ATTACHMENT A: OPERATION WITH REACTOR COOLANT PUMP POWER MONITORS

I. CHANGE REQUEST

These changes address the current reactor refueling for Cycle V. The changes are supported in BAW-1767, Crystal River Unit 3 - Cycle 5 Reload Report, March 1983. Item II of this attachment lists the proposed Technical Specification changes.

FIGURE 2.1-2

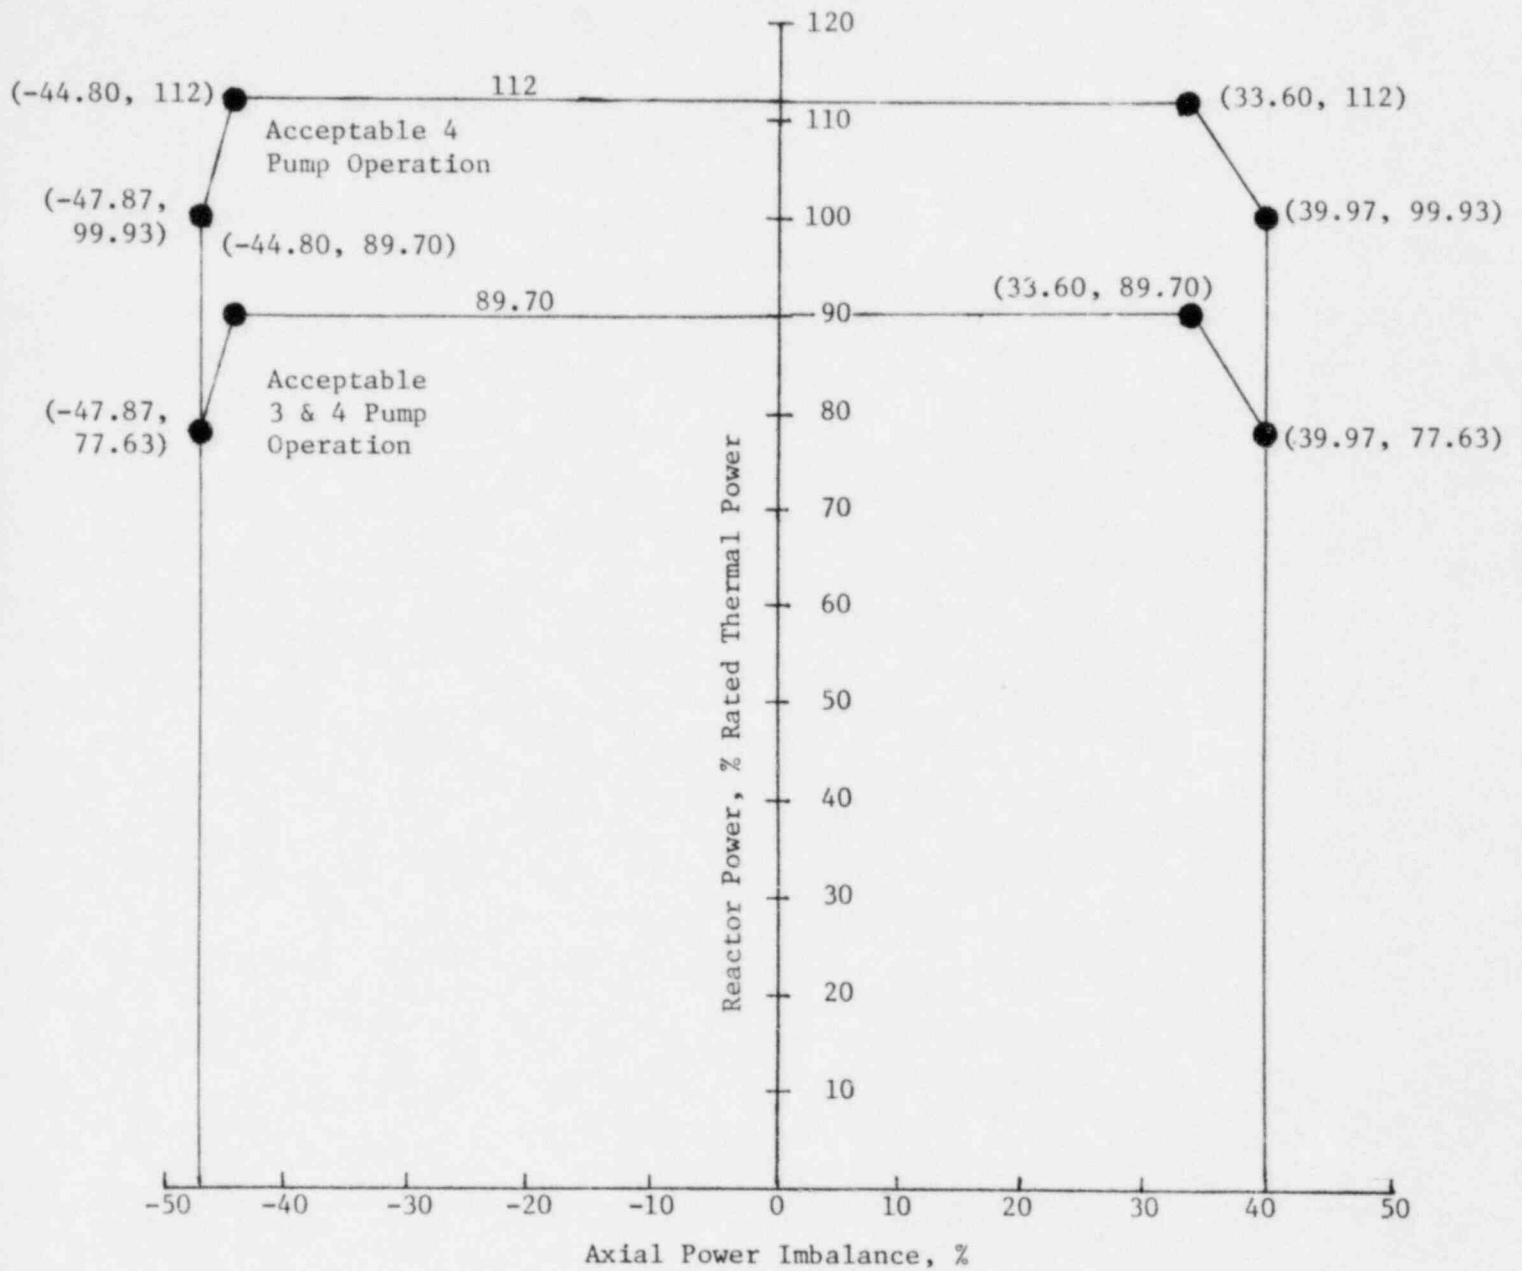
1. Reactor core safety limits and trip setpoints for reactor thermal power and axial power imbalance.
2. Minimum boric acid and borated water volumes.
3. Reactor Regulating rod group insertion.
4. Reactor axial power shaping rod group insertion.
5. Reactor axial power imbalance limits
6. Reactor Coolant Pump Power Monitor operability response time requirements.
7. Shutdown Margin Requirements (not supported by BAW-1767 but by Attachment E, Item II).

Crystal River Unit 3 will operate in Cycle V with 76 fresh fuel assemblies. The Cycle V core has been designed with an increased cycle lifetime of 460 effective full power days (EFPD) and the incorporation of burnable poison rod assemblies to aid in reactivity control. As stated in BAW-1767, certain Technical Specifications require revision due to these fuel and thermal characteristics changing.

FIGURE 2.2-1

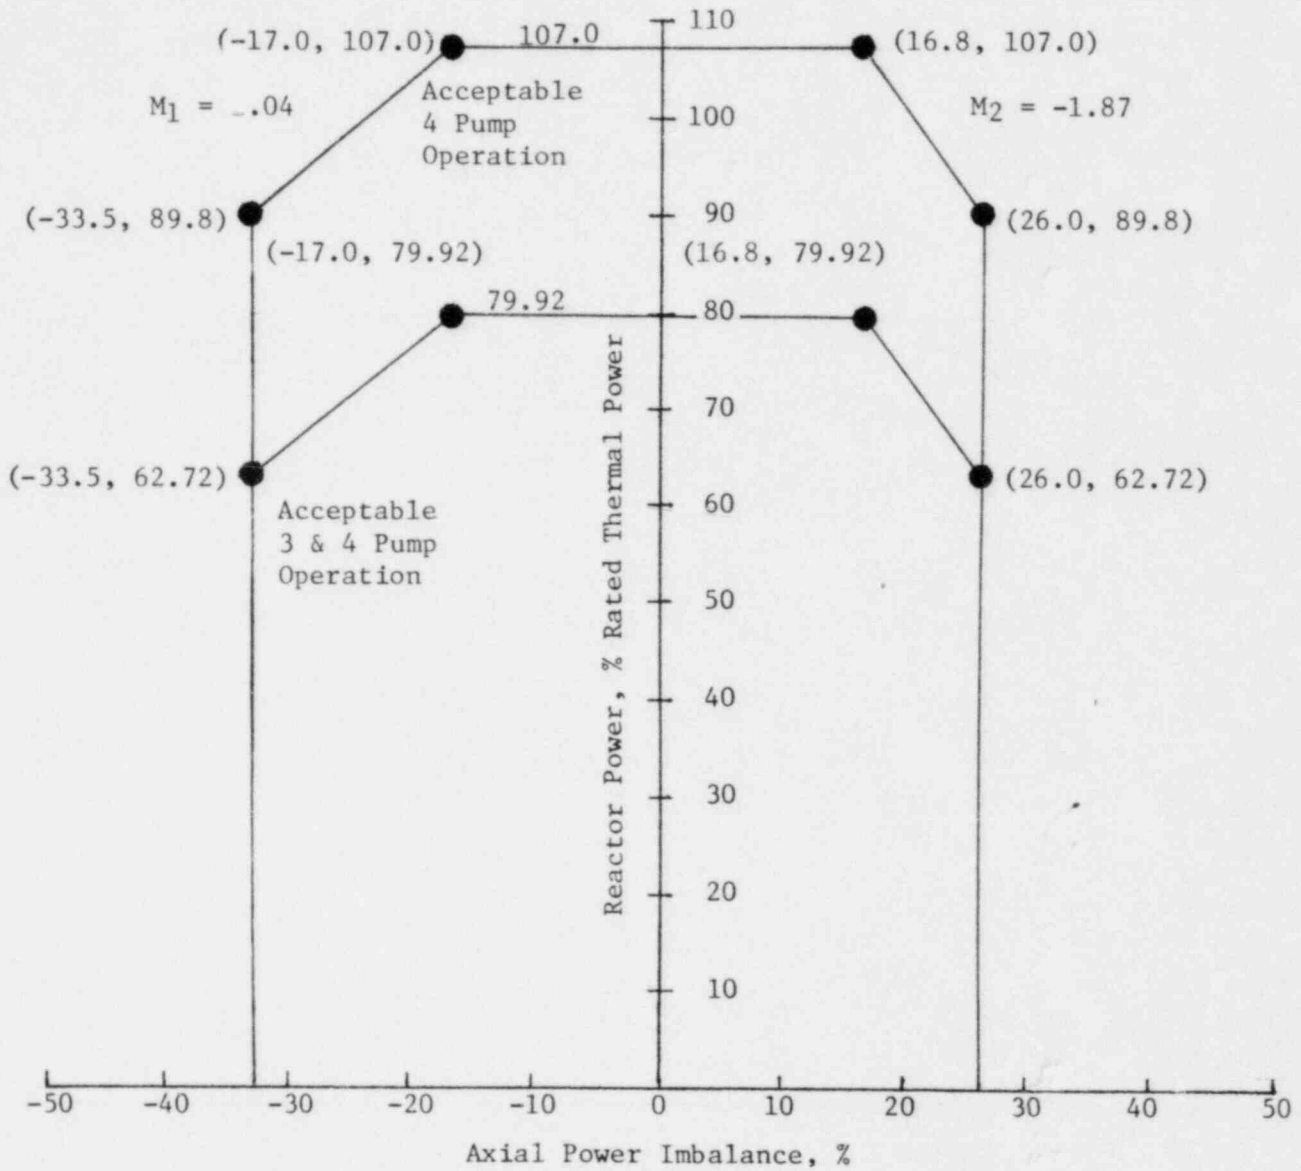
3. RCS Outlet Temperature - High	$\leq 618^{\circ}\text{F}$	$\leq 618^{\circ}\text{F}$
4. Nuclear Overpower Based on RCS Flow and AXIAL POWER IMBALANCE (1)	Trip Setpoint not to exceed the limit line of Figure 2.2-1	Allowable Values not to exceed the limit line of Figure 2.2-1
